River Bend September 2004 NRC Written Exam Analysis

Following the administration and preliminary grading of the River Bend September 2004 NRC Written Examinations, an exam analysis was completed by the River Bend Training Department with input from the applicants and exam developer in accordance with NUREG-1021, ES-403. The attached table contains the results of the analysis of both written exams in terms of questions missed by each candidate and the INCORRECT answer chosen. The Analysis Comments column summarizes the results of the detailed review of those questions that half or more of the Reactor Operator and/or Senior Reactor Operator candidates missed. The validity of the question and accuracy of the answer key were reviewed for each of those questions.

Questions 7, 18, and 60 are being submitted for deletion from the exam following the exam analysis. All three were found to have no correct answer. Each question is attached following the exam analysis table with justifications for removal and supporting reference materials.

ERIS Screen Printouts for Full Power, Hydraulic ATWS, and successful scram conditions.

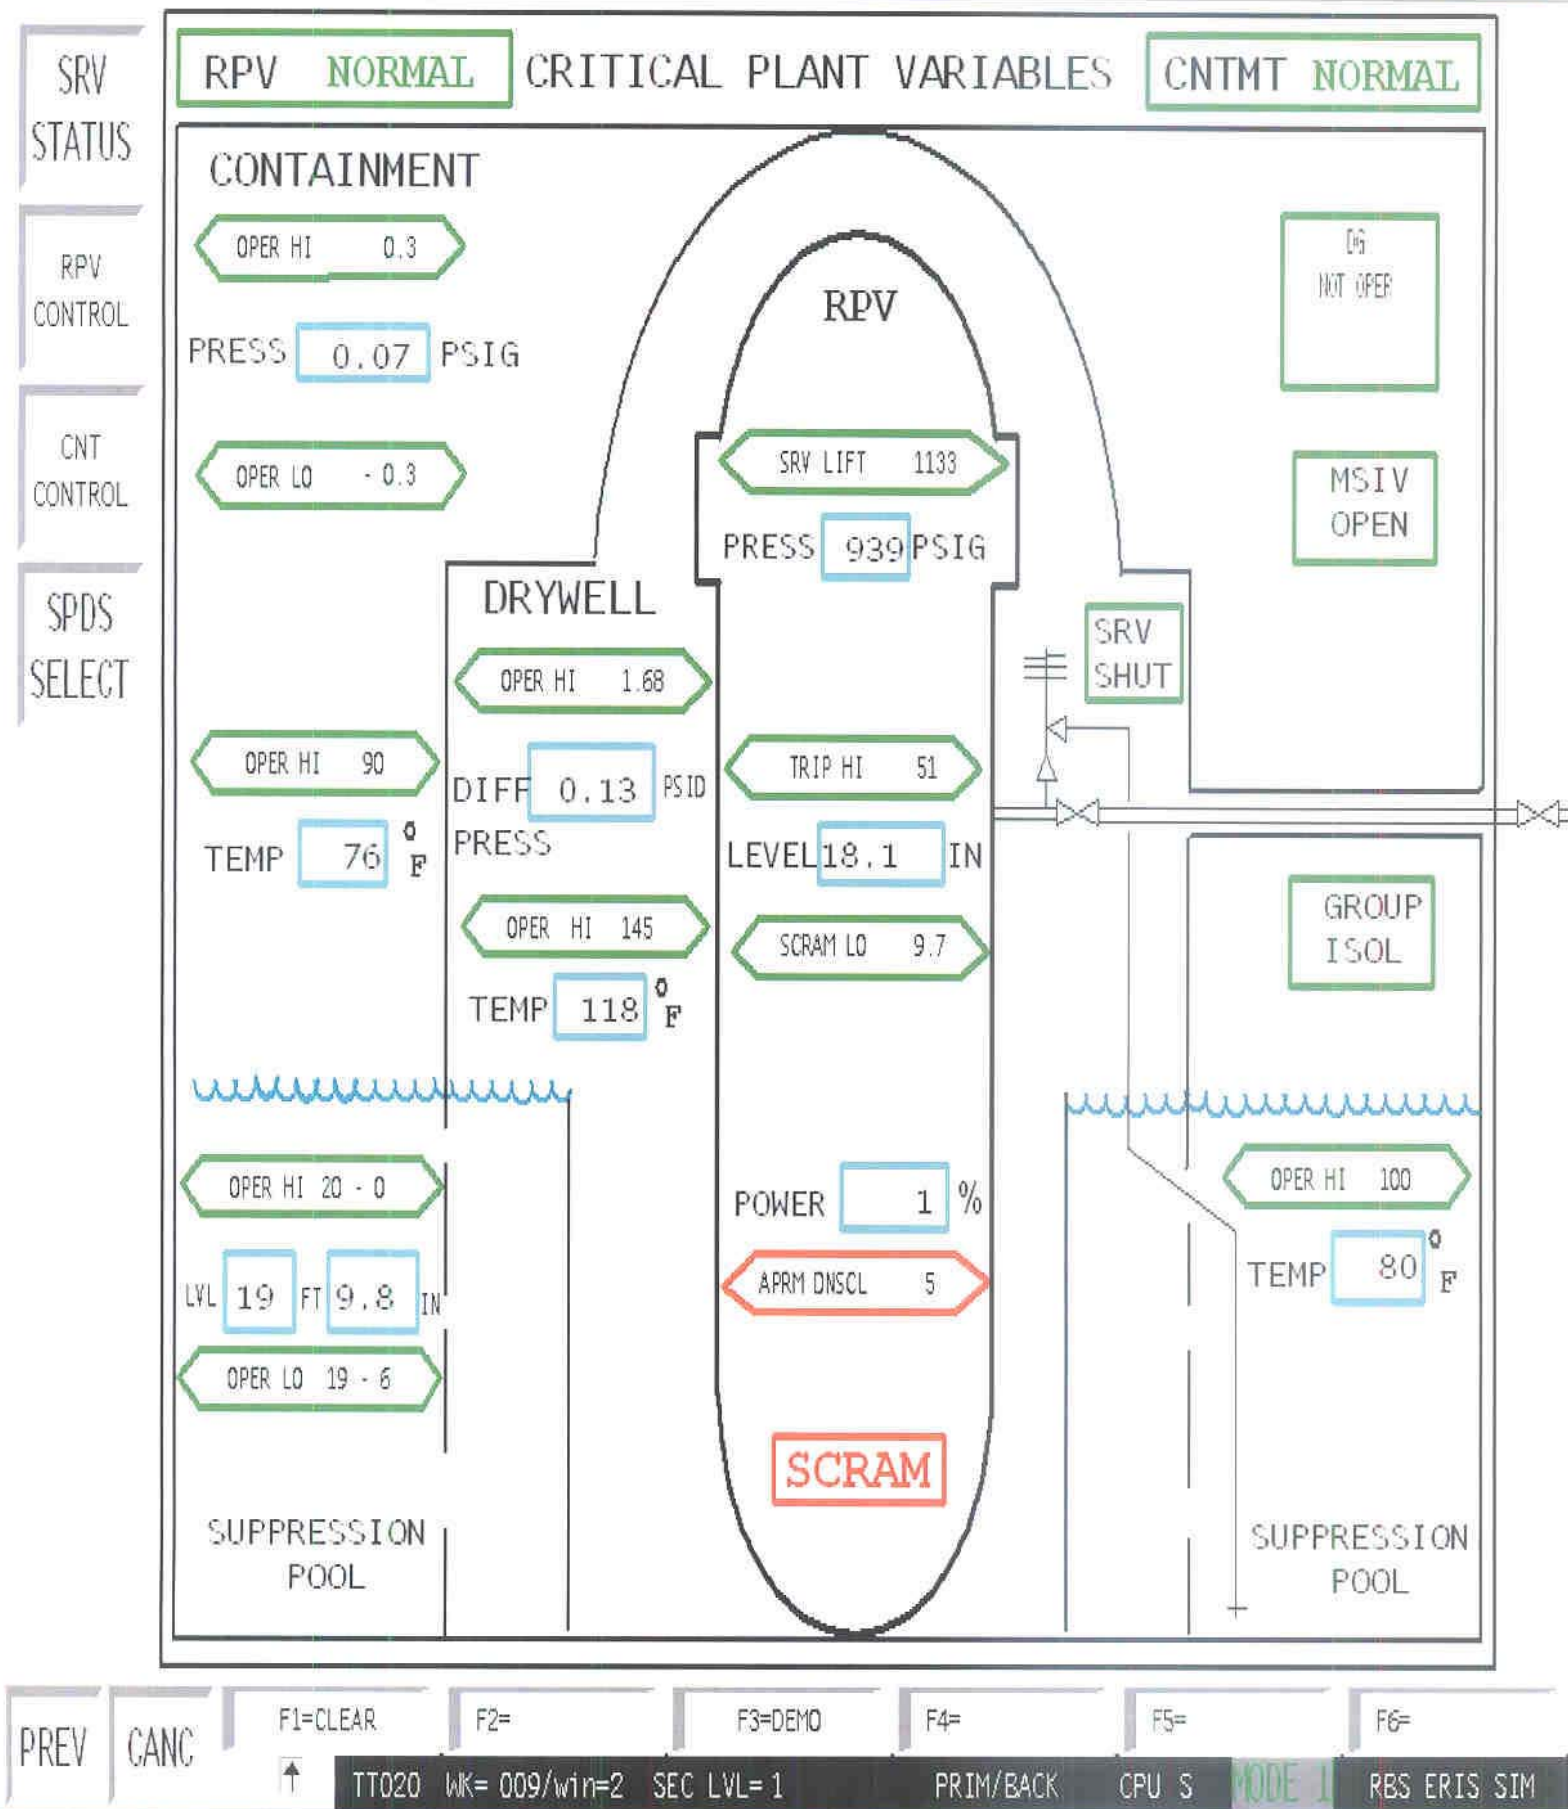
The correct answer per the KEY for this question was choice B. It is correct that NO SCRAM will be displayed. However, the highlight box around the NO SCRAM status box is colored cyan (light blue), NOT green as is the case for other status boxes on ERIS, such as MSIV status and GROUP ISOL status.

No change in color occurs and the highlight box remains cyan colored. The only other state for this box is when scram conditions are detected (One of the RPS K14 relays in each RPS trip system de-energized and all control rods at position '00') when the displayed status will change to SCRAM in red lettering and the highlight box changes to red.

Attached are ERIS screen printouts from the simulator showing the status of this parameter 1) at rated power, 2) following a hydraulic ATWS and 3) following a normal successful scram.

Therefore, the only correct answer for this question was that the status box would be NO SCRAM highlighted in cyan or light blue which was not provided as a choice.

DELETE the question from the exams because there is NO CORRECT ANSWER.
